TECHNICAL NOTE 1

DATE:	27 April 2023	CONFIDENTIALITY:	Public
SUBJECT:	A66 NTP Noise and Vibration Queries - Deadline 7		
PROJECT:	A66 NTP	AUTHOR:	Various
CHECKED:	Sarah Whydle	APPROVED:	Hywel Roberts

A66 NORTHERN TRANS PENNINE NOISE AND VIBRATION ASSESSMENT

Figure 1 – Location of additional barrier and assessed receptors (provided by the Applicant)

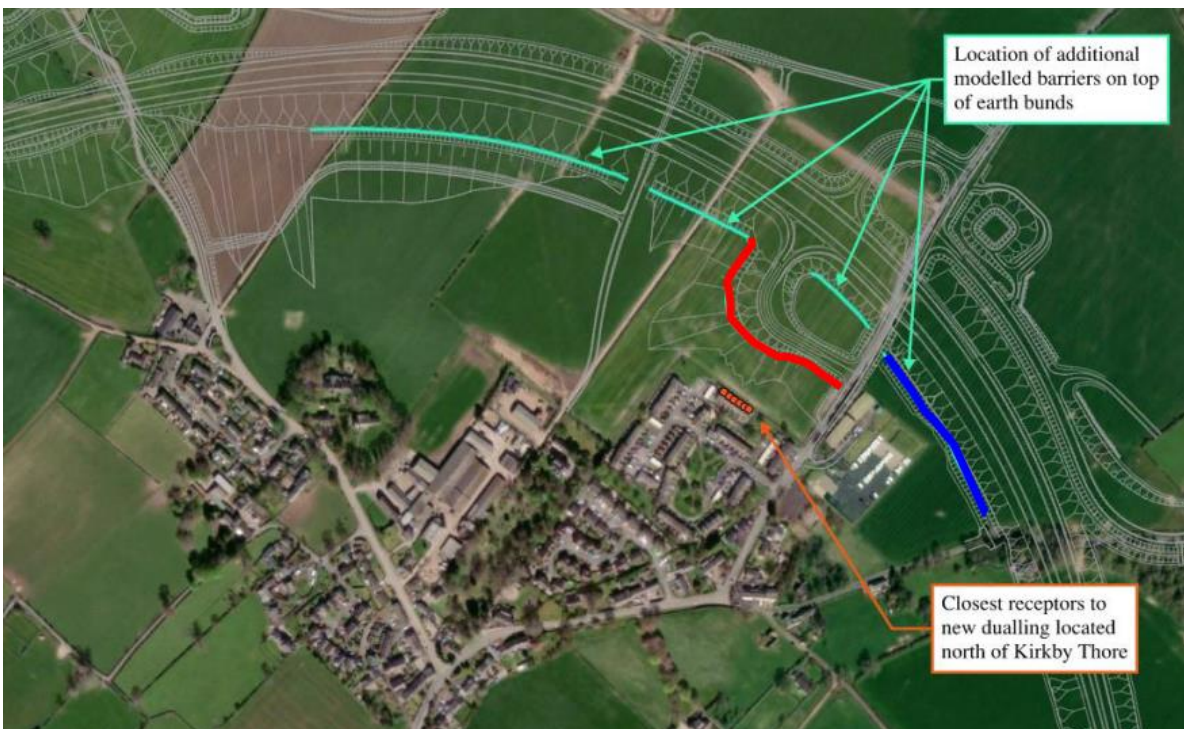
The Councils would like clarification as to whether the inclusion of the barrier as marked in red in Figure 1 is delivering any additional attenuation above that which the bund surrounding the slip road is providing, or whether the barrier shown in dark blue and cyan is delivering the predicted reduction (~-2dB). The Councils would therefore like a more detailed understanding of the source of the resulting noise increase (e.g. partial levels to understand the noise levels from the segments of road(s)) at Sanderson Croft as well as information on the relative heights of the bunds on the southern side of the carriageway where barriers have been modelled.
